Abbreviated Procedures**STANDARD INSPECTION REPORT OF A LIQUID PIPELINE CARRIER**

Name of Operator: ExxonMobil Pipeline Company		
OP ID No. ⁽¹⁾ 4906	Unit ID No. ⁽¹⁾ 1255	
H.Q. Address:	System/Unit Name & Address: ⁽¹⁾	
ExxonMobil Pipeline Company 800 Bell Street Houston, TX 77002	ExxonMobil Pipeline Company 110 Cemetery Road Bridger, MT 59014	
Co. Official: Patrick Doolan	Activity Record ID#: 123899	
Phone No.: 713-656-2227	Phone No.:	
Fax No.: 713-656-2170	Fax No.:	
Emergency Phone No.:	Emergency Phone No.:	
Persons Interviewed	Titles	Phone No.
Guy Peltier	Pipeline Safety Advisor	(713) 656-3504
Larry (Doc) Hawthorne	Training Advisor	(903) 879-0313
Jeb Montgomery	Area Superintendent	(406) 657-5400
Steve Everett	Technician Leader	(406) 670-7520
James Althoff	Senior Technician	(406) 671-1108
PHMSA Representative(s) ⁽¹⁾ Michael Petronis Inspection Date(s) ⁽¹⁾ July 27 - July 30, 2009		
Company System Maps (copies for Region Files): No		
Unit Description:		
The Silvertip Pipeline delivers crude oil from the Silvertip Station (Elk Basin) in extreme southern Montana east of Belfry to the ExxonMobil Refinery in Billings, MT. The pipeline is able to receive crude oil from Kinder Morgan's Ed

Silvertip Scraper Trap Before Work

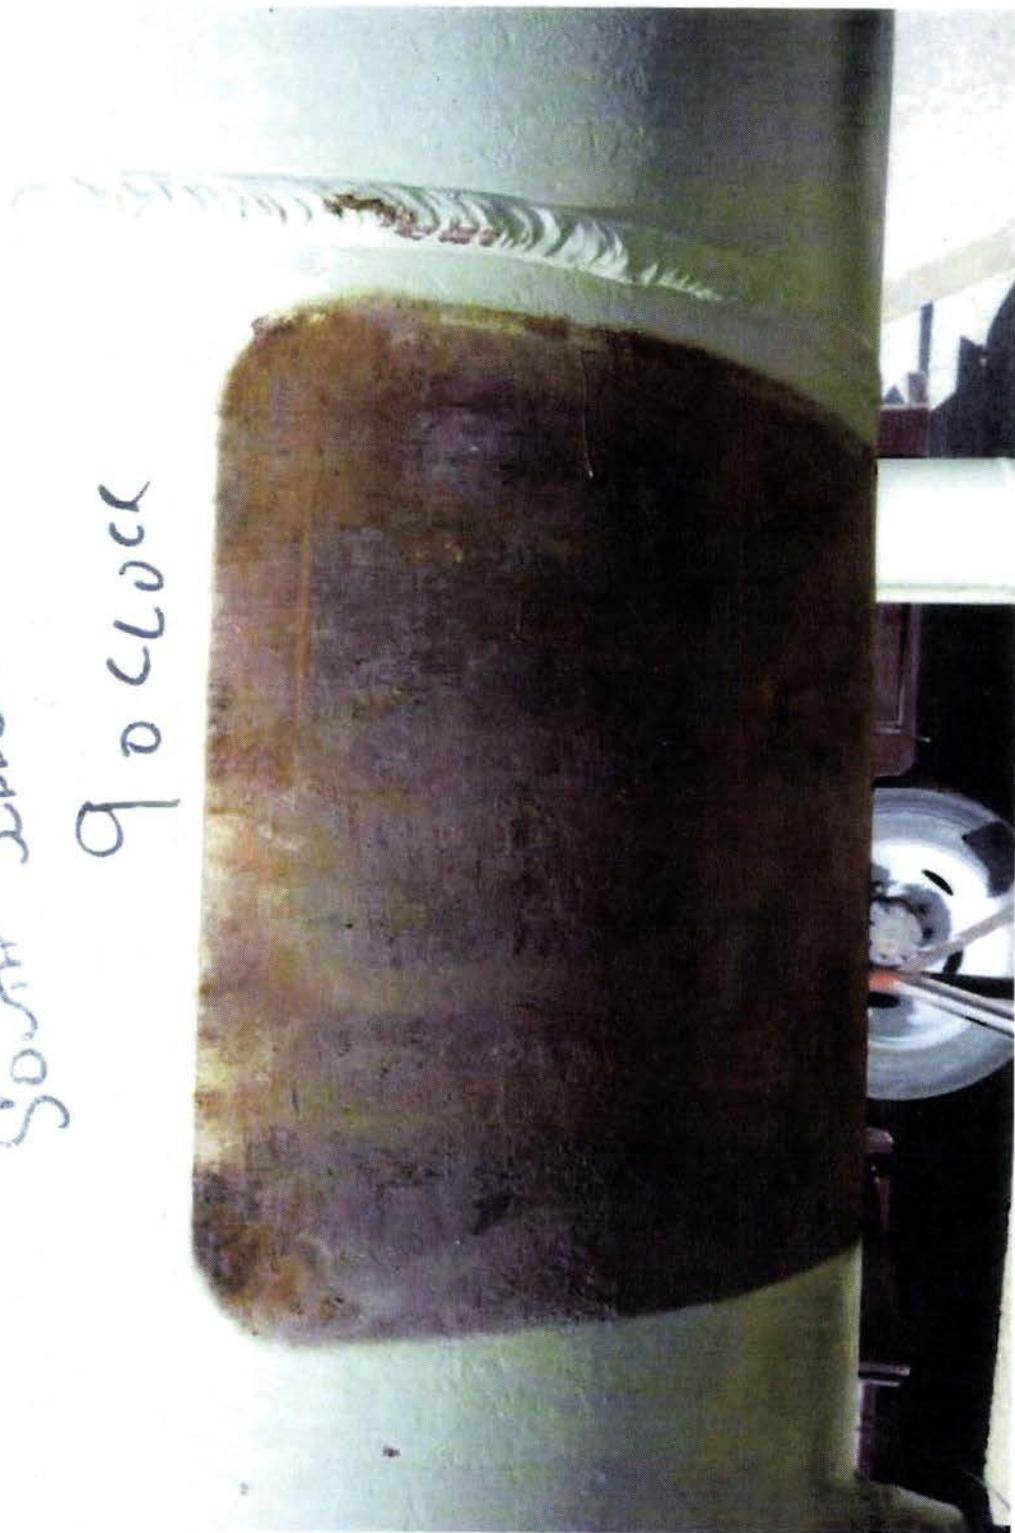
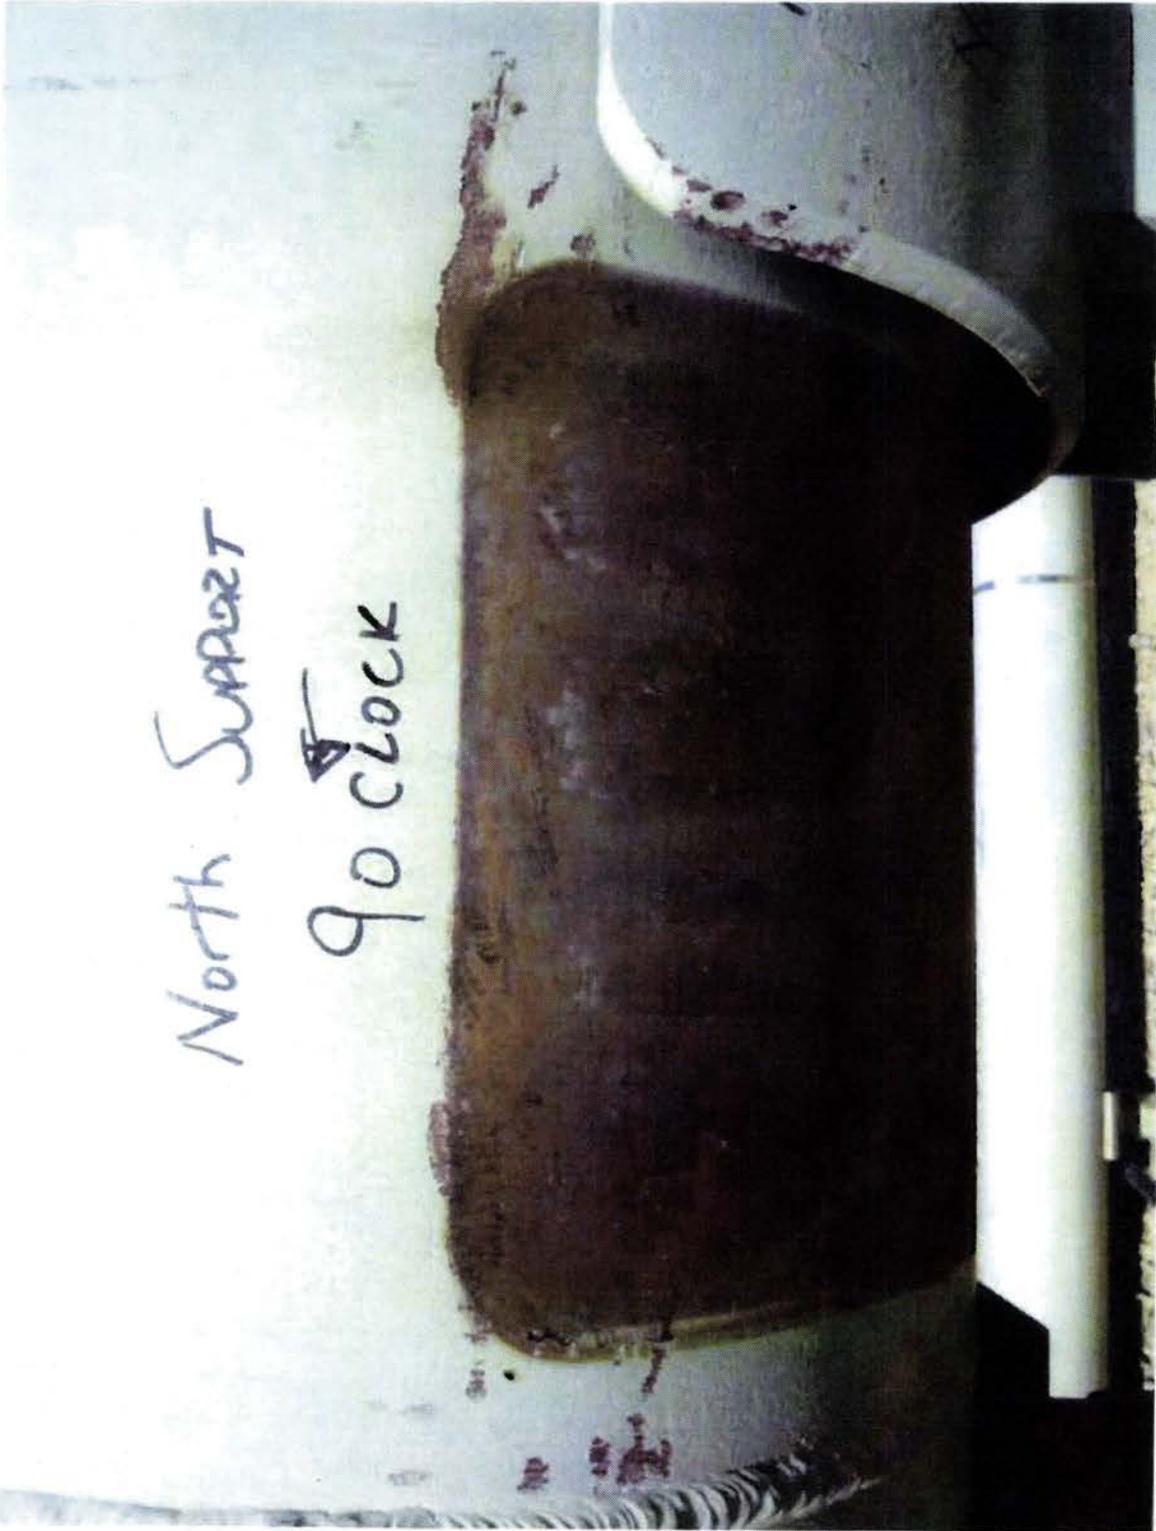
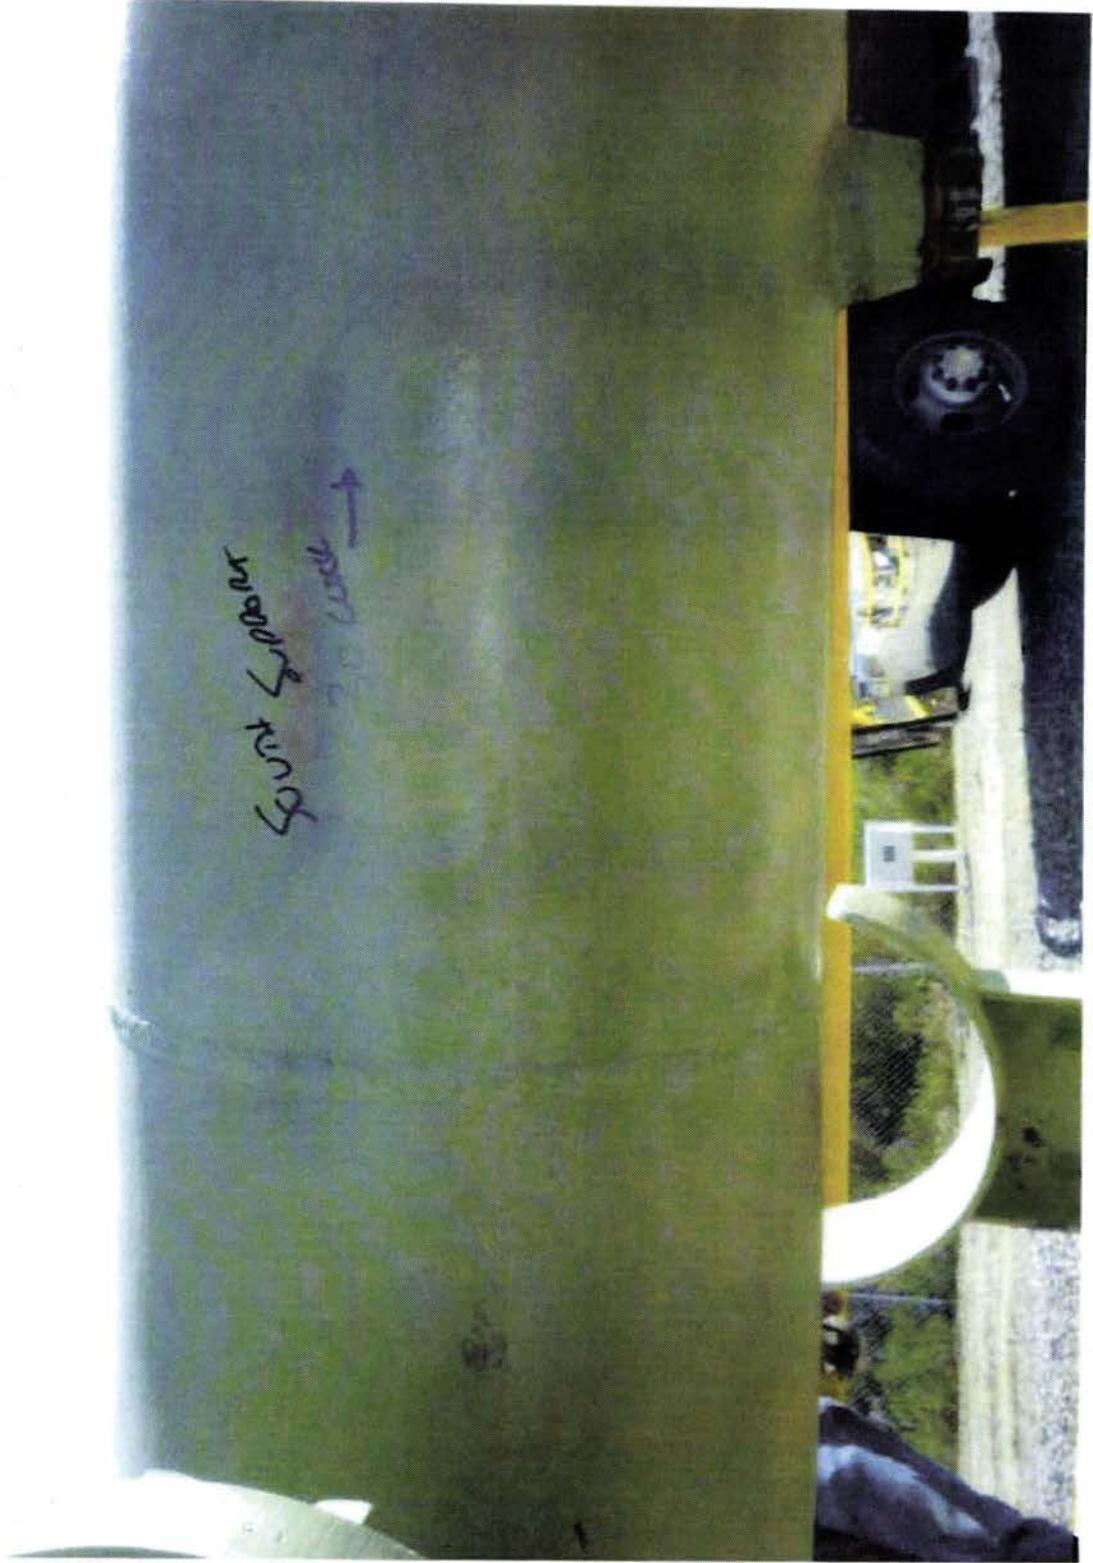
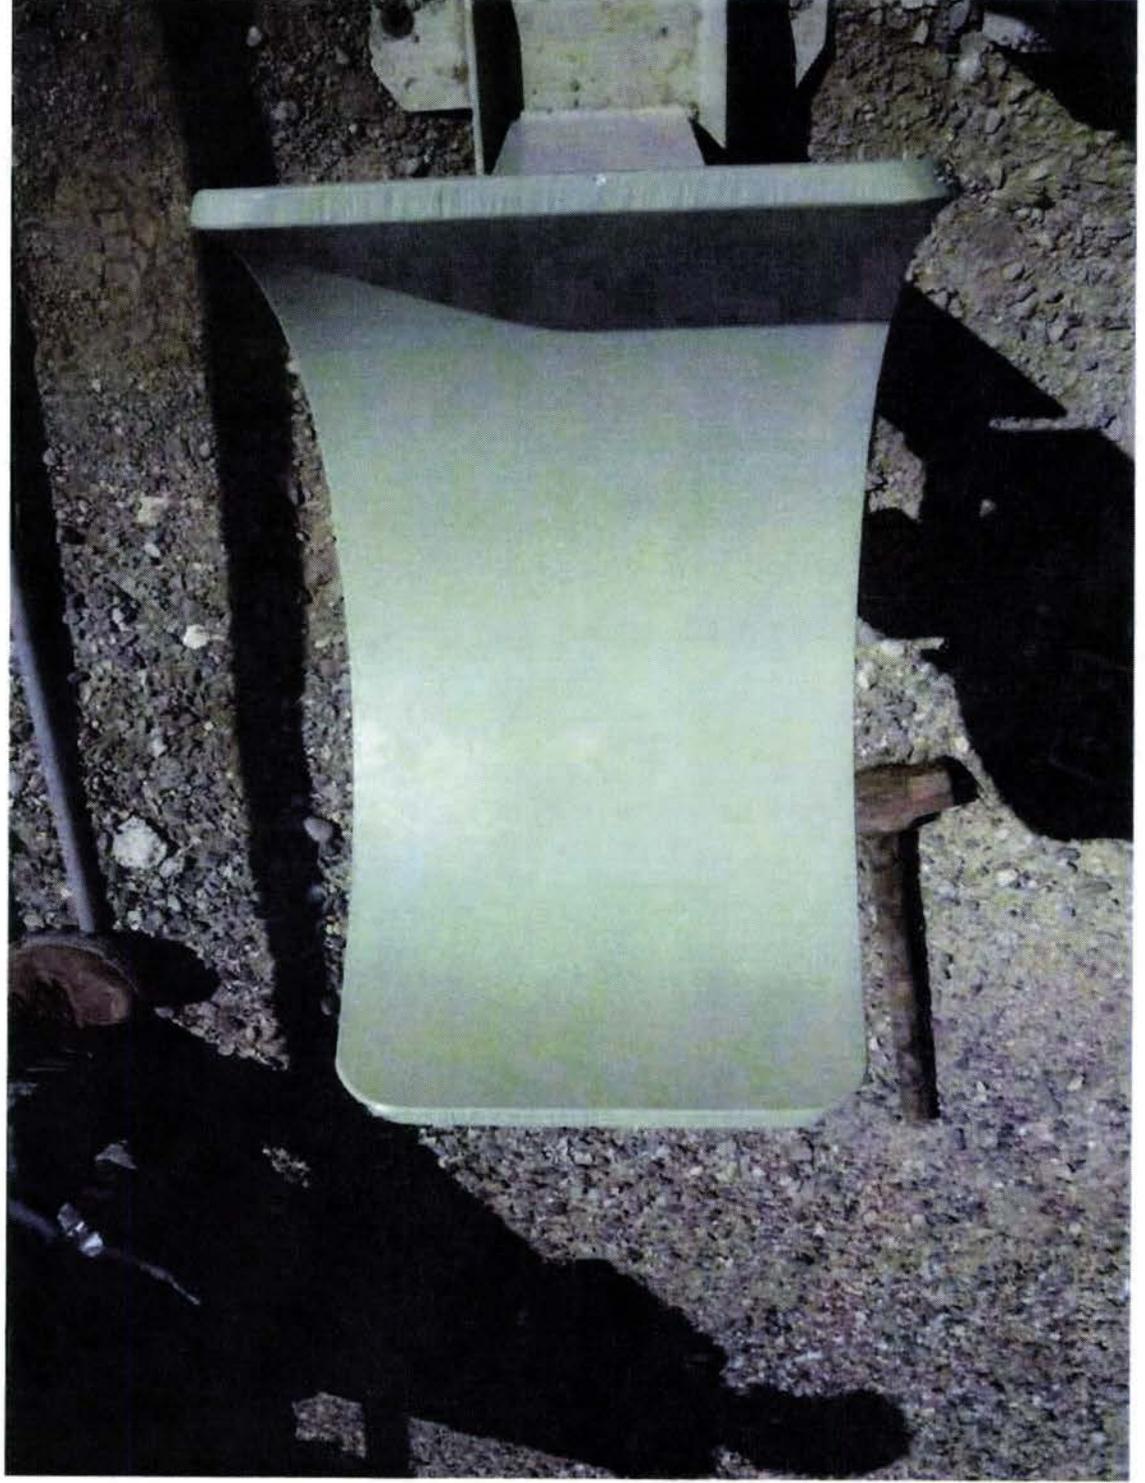
Silvertip Station – Launcher barrel support/pipe interface

Silvertip Scraper Trap After Work.
Completed 8-18-09
